## Accessibility Survey

## City of Downey Arrington Avenue - Muller Street to Cul-De-Sac

### City of Downey Arrington Avenue - Otto Street to Florence Avenue

## City of Downey Arrington Avenue - Telegraph Road to End

#### Change in Level South of Telegraph Road @ 33.958561814662, -118.108591586351

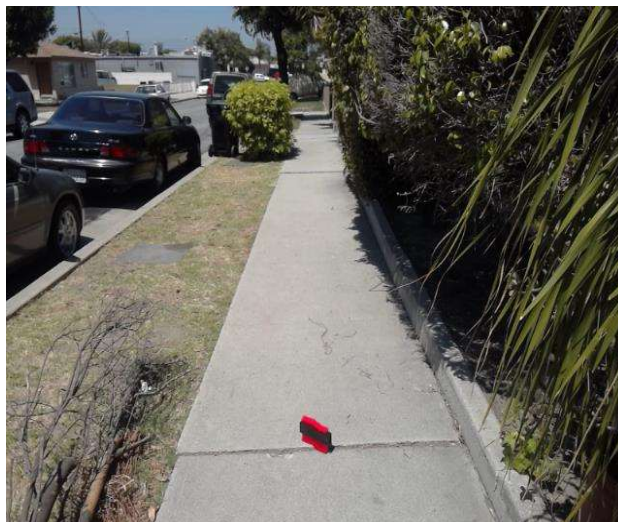
There is a change in elevation greater than recommended value.

**On-Site Finding** 0.50 inches

Ensure that the change in elevation is within the recommended value.

Recommendation Up to 0.25 inches
